RC-67M

RC-67M has been updated to include more details to be consistent with both ADAAG and PROWAG.

Sidewalk Typical Section

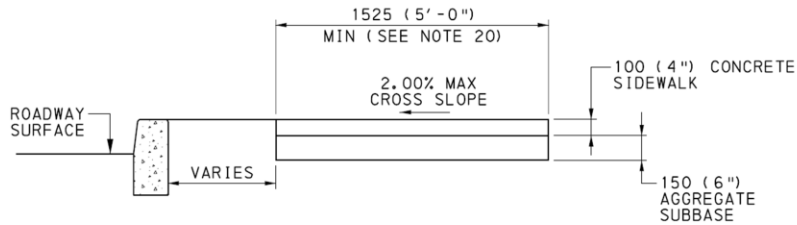
20. SIDEWALK WIDTH MAY BE REDUCED TO 1220 (4'-0"), WHEN PASSING AREAS 1525 X 1525 (5'-0" X 5'-0") ARE PROVIDED EVERY 61 METERS (200').

A Sidewalk typical section has been added to RC-67M.

The minimum sidewalk width is 5'. This width maybe reduced to 4' when passing areas are provided every 200'. Max 2% cross slope is also strictly enforced.

Depressed Curb for Curb Ramps

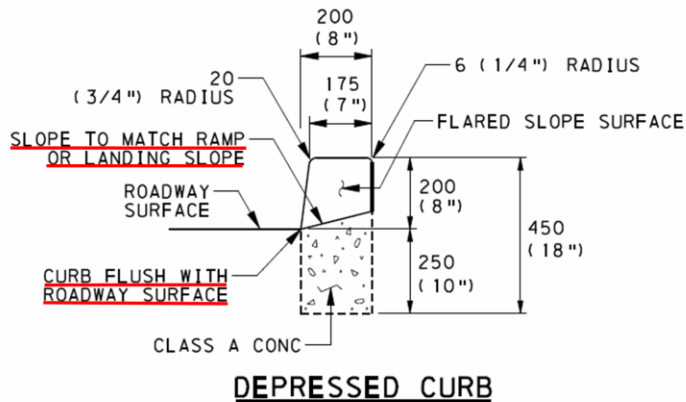
Depressed curb for curb ramps has also been added to RC-67M. The depressed curb must be flush at the curb ramp. The standards are very clear that a 1/4" max lip can be located in the pedestrian path, but at a curb ramp the depressed curb shall be flush. At driveways the depressed curb may have an 1 1/2" lip but not at curb ramps.

The top of the depressed curb at curb ramps may also be sloped to match the adjacent curb ramp or landing. This will help keep drainage at the flow line.

Separate Ramps Preferred

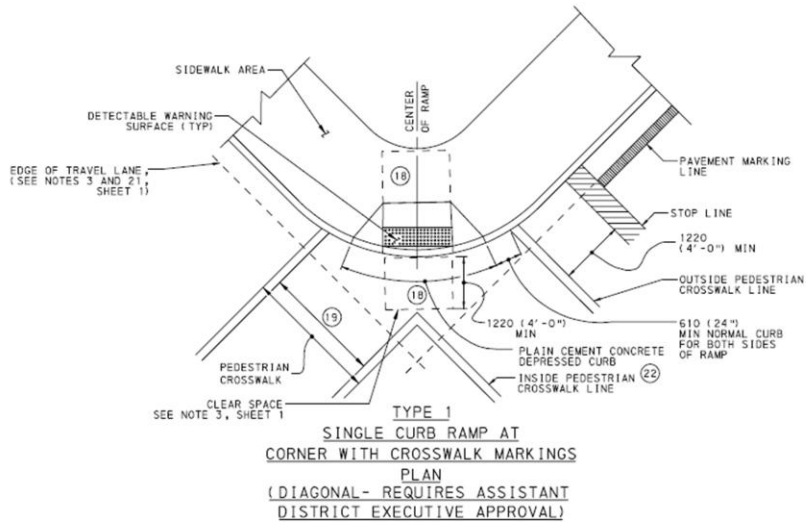
Separate ramps are preferred.

For this slide you can see each crossing has a separate curb ramp. For this type of installation, the depressed curb for the curb ramp must be completely within the markings. The flares may extend beyond the markings as shown on the left curb ramp.

Diagonal Ramps & Crosswalks

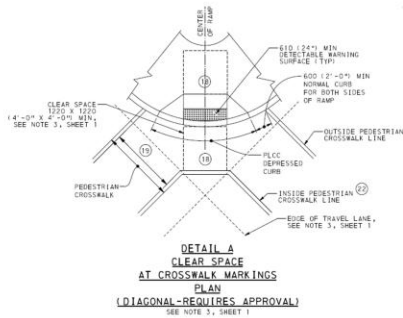
Diagonal ramps are NOT preferred.

For this slide you can see 2 crossings that merge at a single curb ramp. For this type of installation, the curb ramp must be completely within the markings, including the flares as shown.
